DOCUMENT TRANSMITTAL

TRANSMITTAL NO: DCD 92-934

E. I. Hatch Nuclear Plant

TABLE 1-a

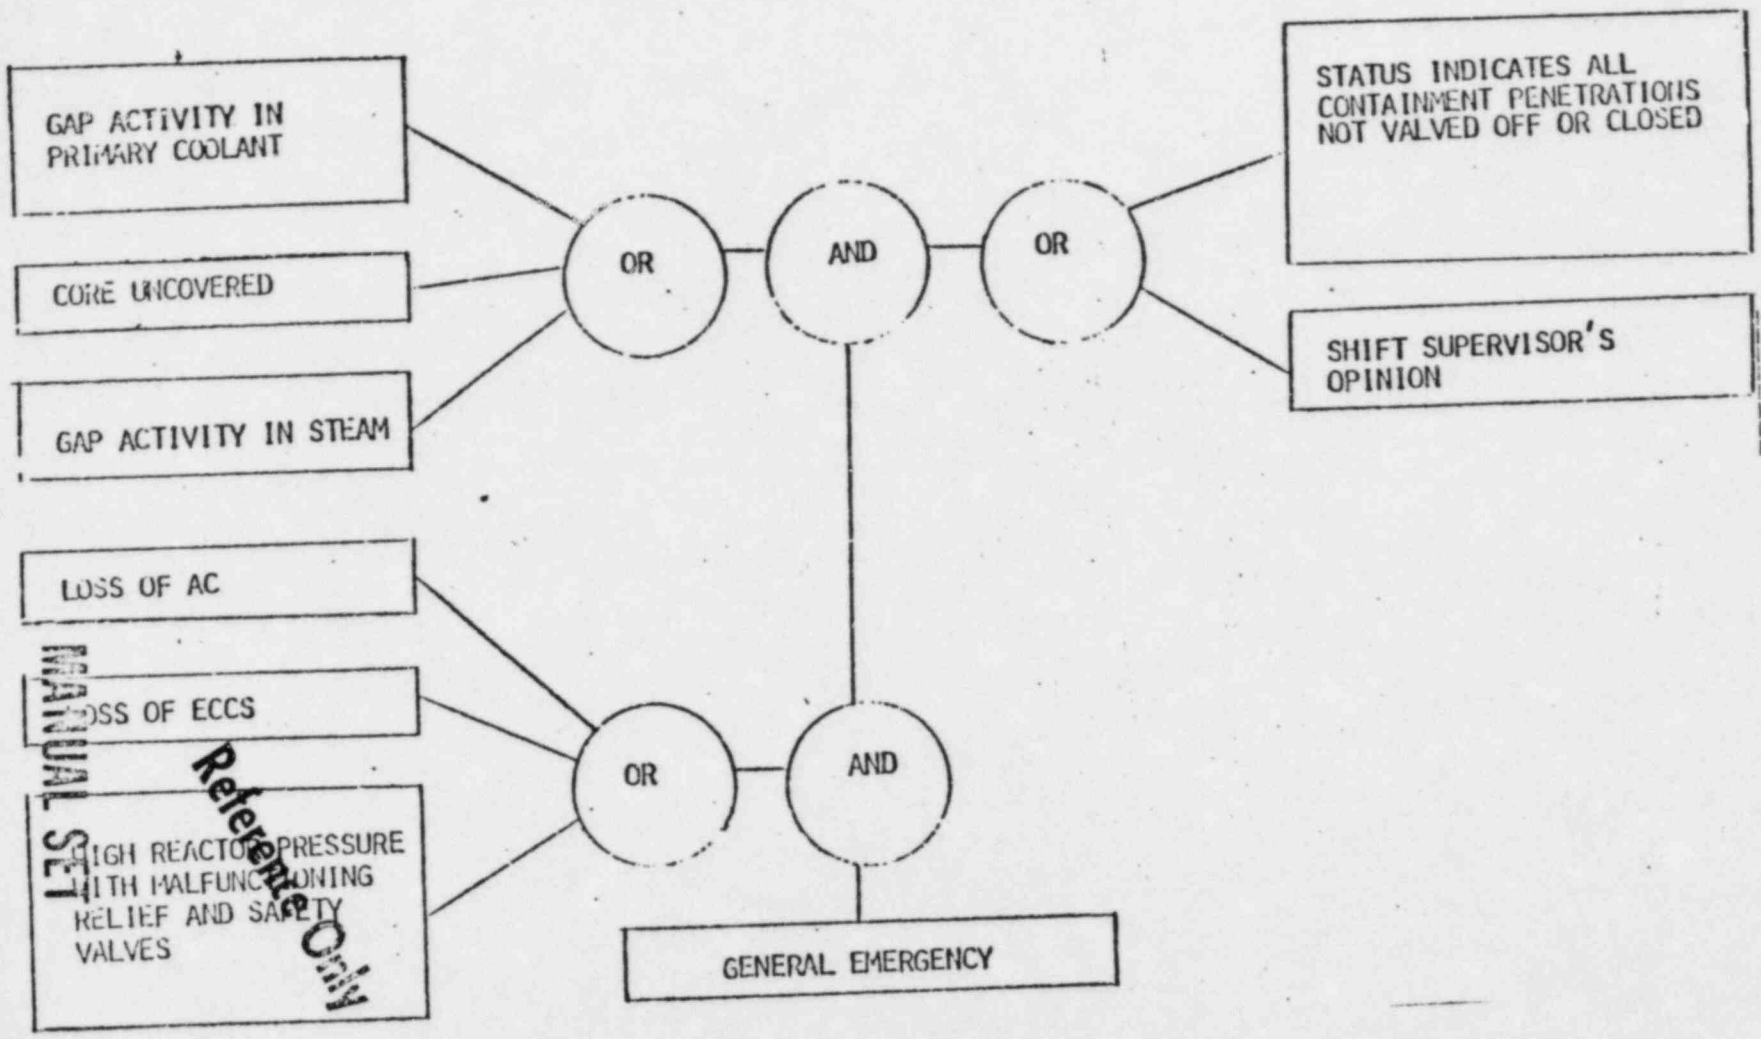
- ① Pg 1-C, Add. Note as shown on attached
- ② Pg. 5 Table 1 - add changes as shown on attached
- ③ Pg. 5 Table 1 - fix correct "Value" to "Value" on all Tables as shown
(Reference NRC item 81-30-22)

FIGURE 1
EARTHQUAKE RESPONSE FLOW CHART

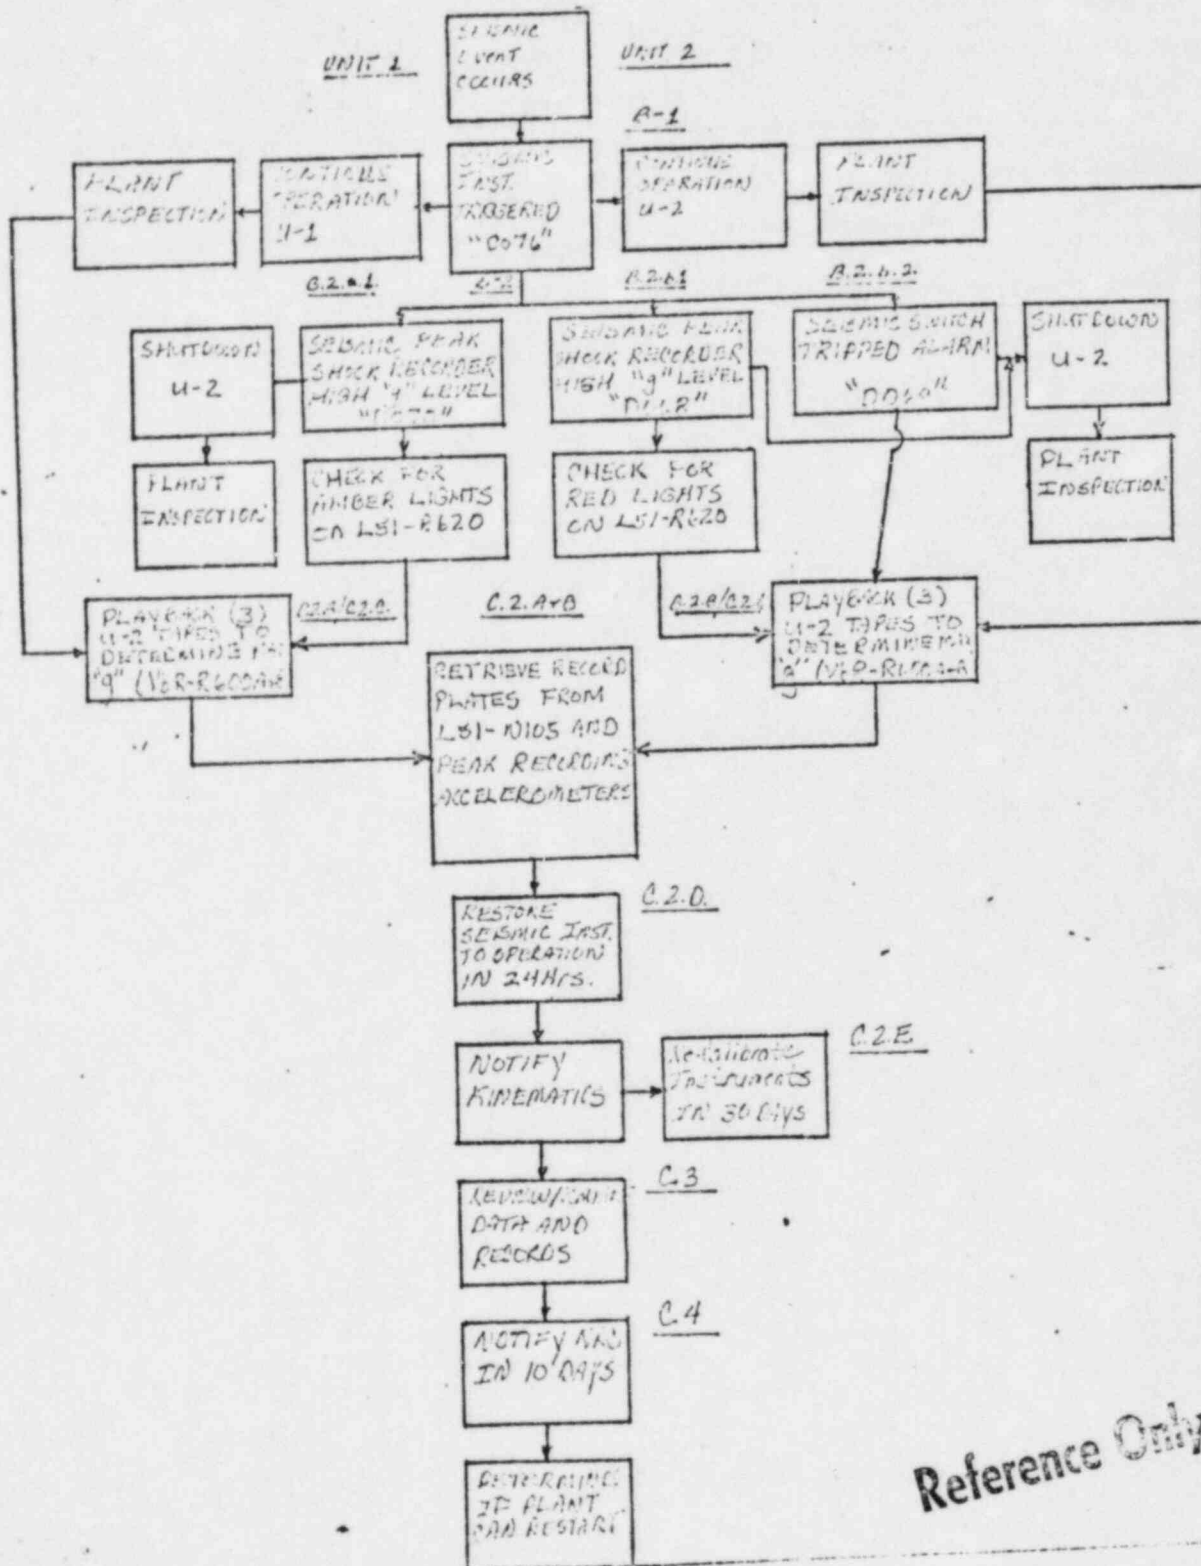
between procedure, equipment, and component
classification guidelines also to resolve PAU's 100
series instrumentation. Replace Section B and
figure 1 with the included 2 pages (pages 1 and 5)
(The following pages have been removed:
page 2 Section A, page 7 Section C.1, page 6 Section
E.4, and page 9 Section M-3.
